CHANGE ORDER

CHANGE ORDER NO.: 8

PROJECT: PB 05-6 PBA Concourse C Gate Expansion

Applicable Drawing(s): C-12.01

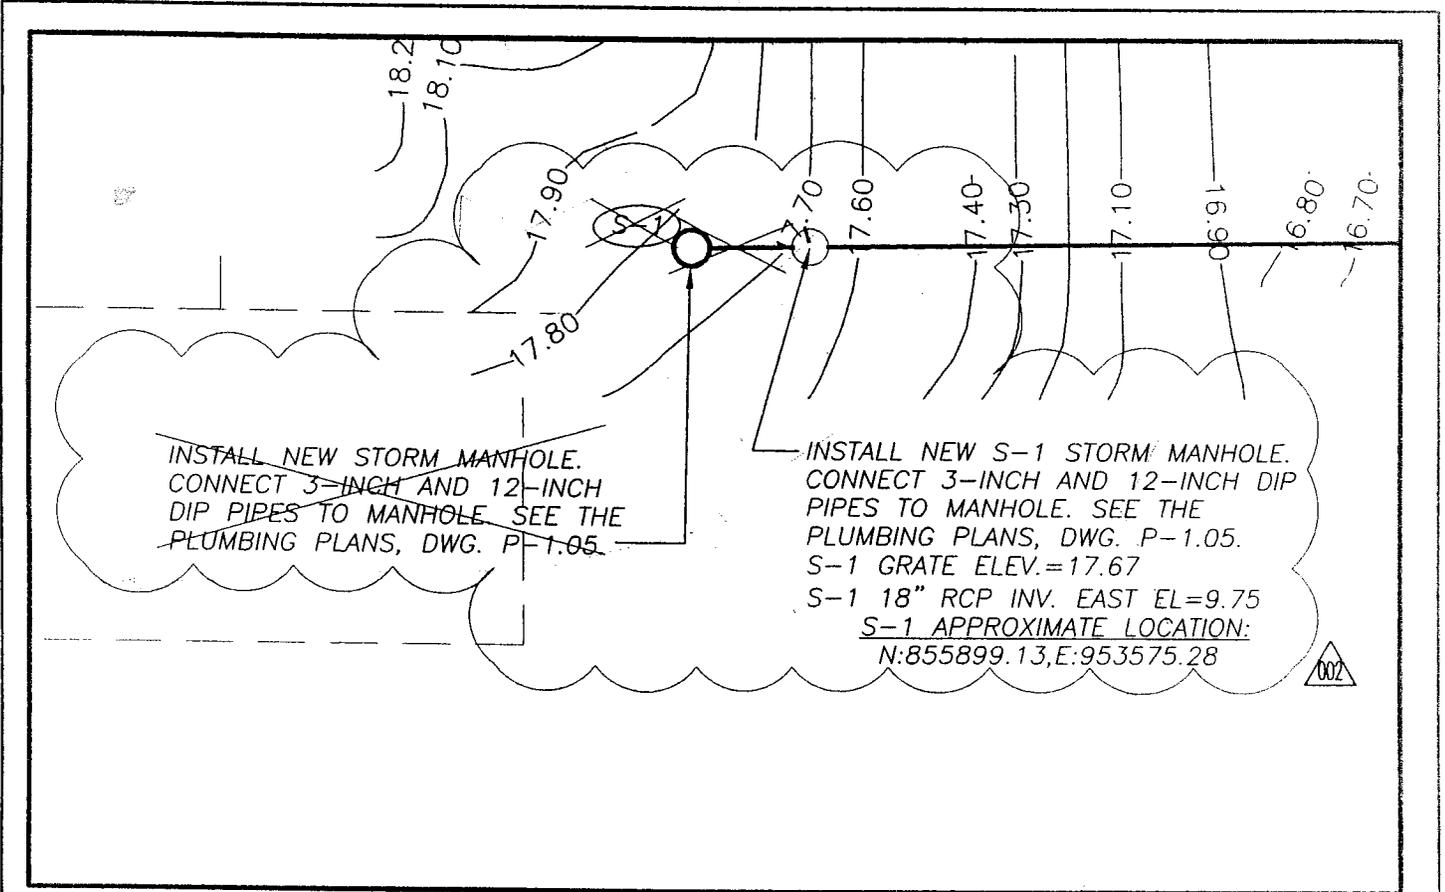
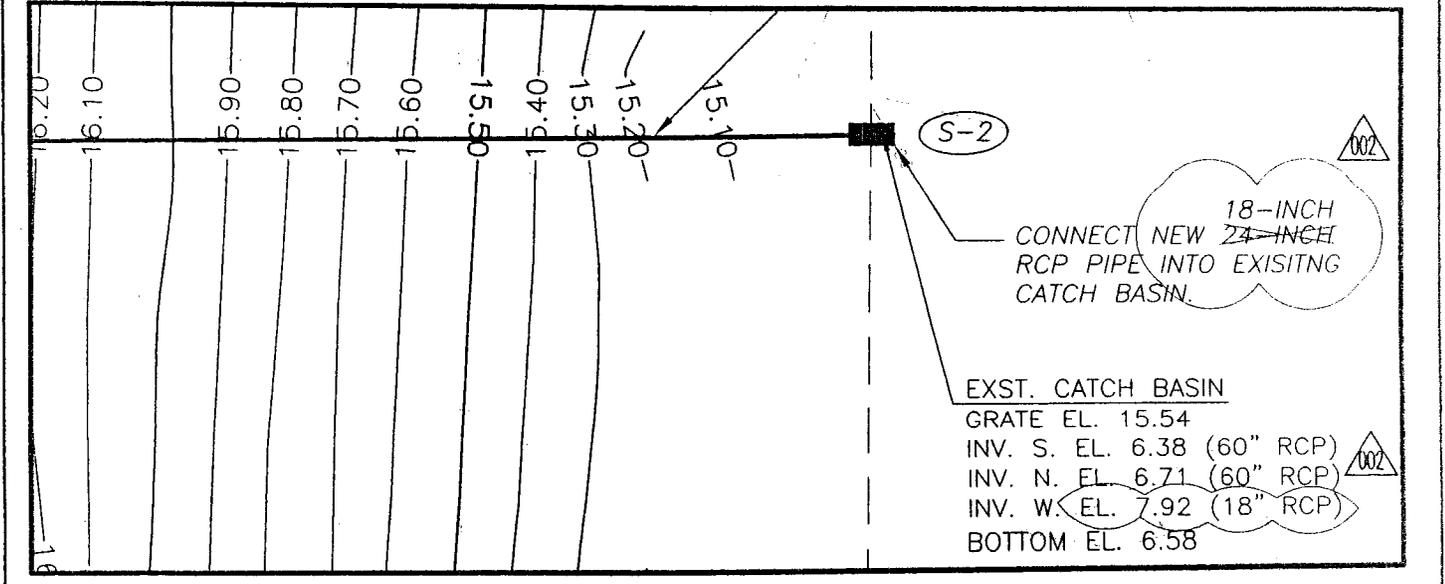
1. Western face of existing S-2 storm structure is not wide enough to accommodate proposed 24" Class V RCP.
2. To avoid proposed building stair foundation, locate structure S-1 approximately 25 ft east of position shown on C-12.01 and adjust condensate and roof drain to connect into revised structure location.

Note: S-1 revised location to the east yields 25LF reduction in Class V RCP.

S-1 NOTE PER RFI-0032: CONSTRUCT 3.5FT DIAMETER STORM MANHOLE TYPE P8 FDOT INDEX 200 AND 201 WITH 12" SUMP TO COLLECT SEDIMENT. MANHOLE STRUCTURE AND COVER SHALL BE MINIMUM H20 TRAFFIC RATED.

DRAWING REF. A-222

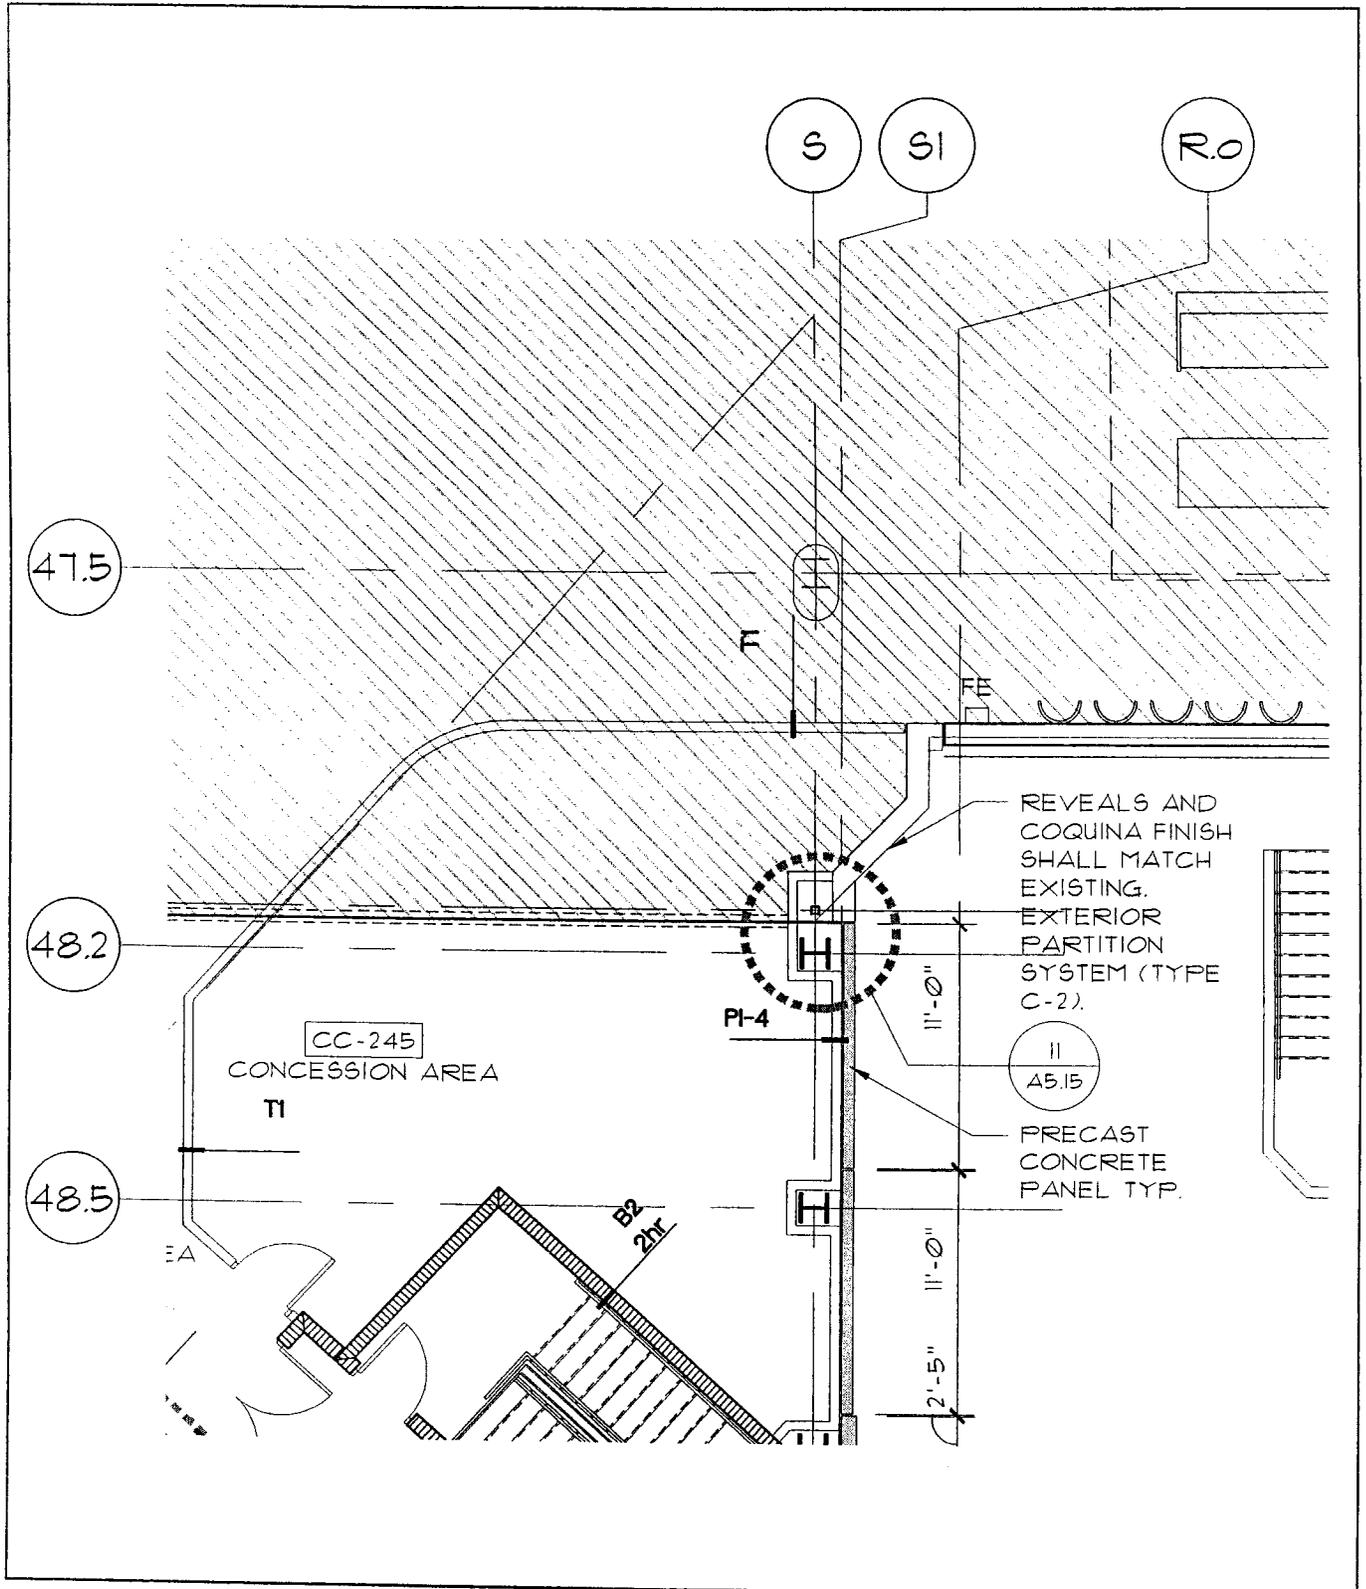
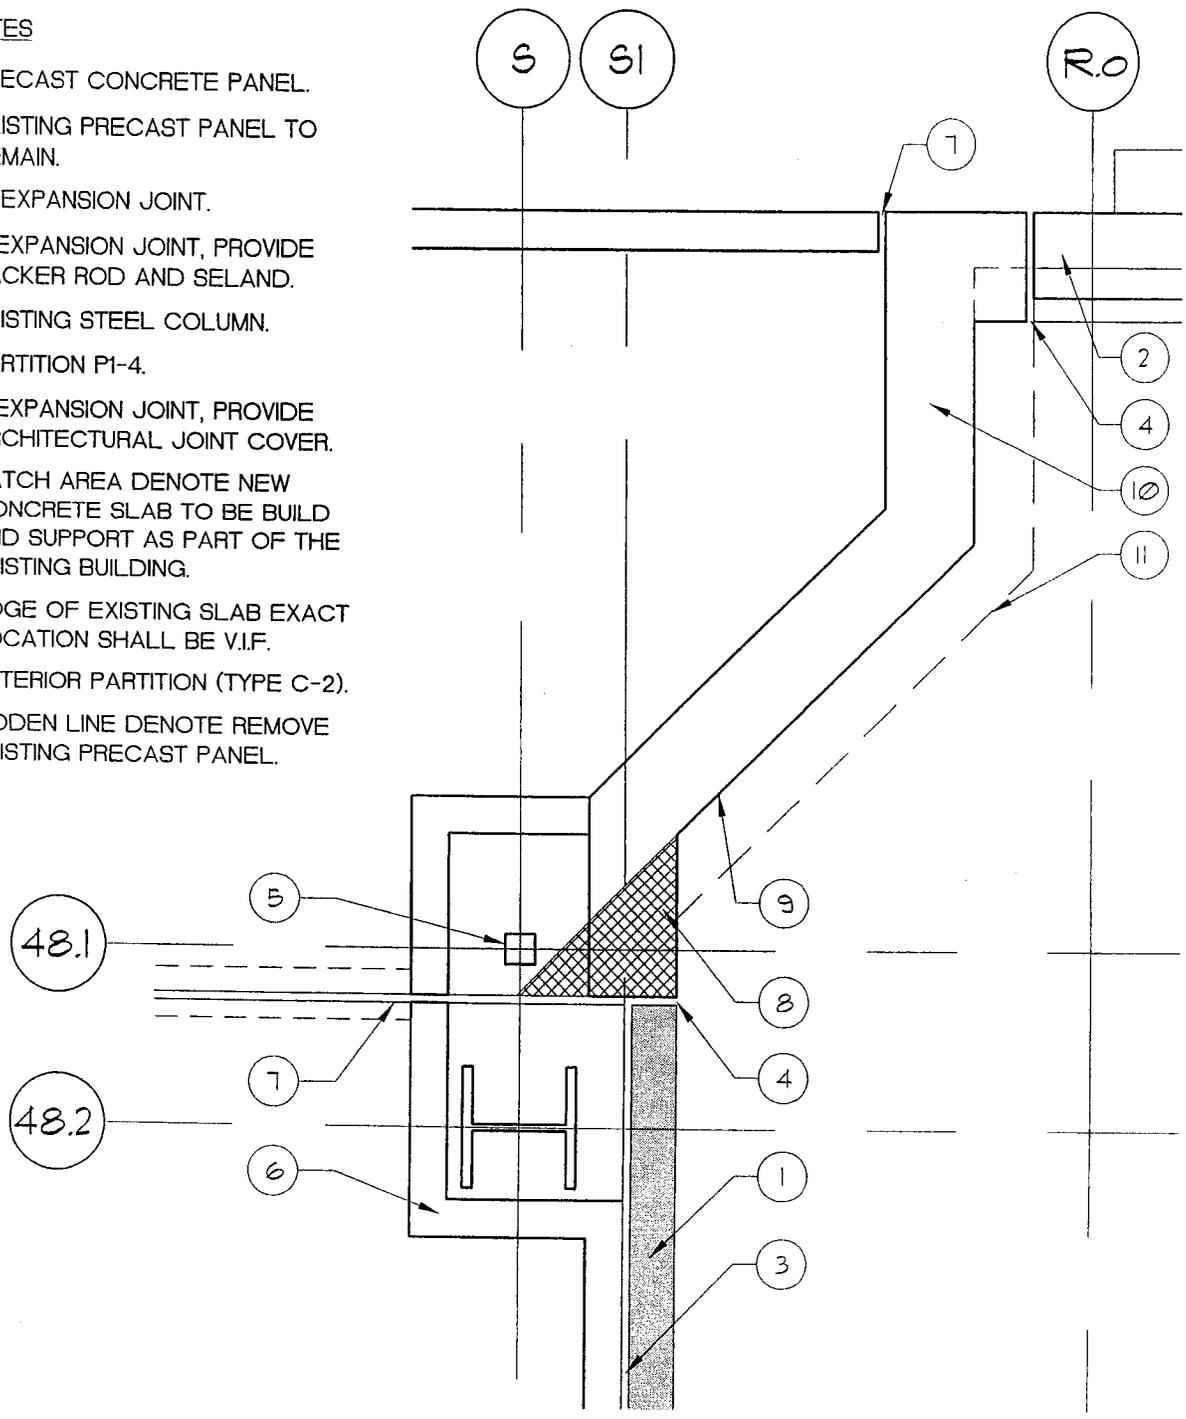
Remove the portion of the existing wall indicated on the attached sketches. Provide and construct a new exterior frame wall as described. The reveals and Coquina finish shall match the existing concourse.

The second floor slab and affected roof area shall be infilled as detailed on the attached sketches. In addition, the new pre cast panels shall be manufactured according to the revised design.
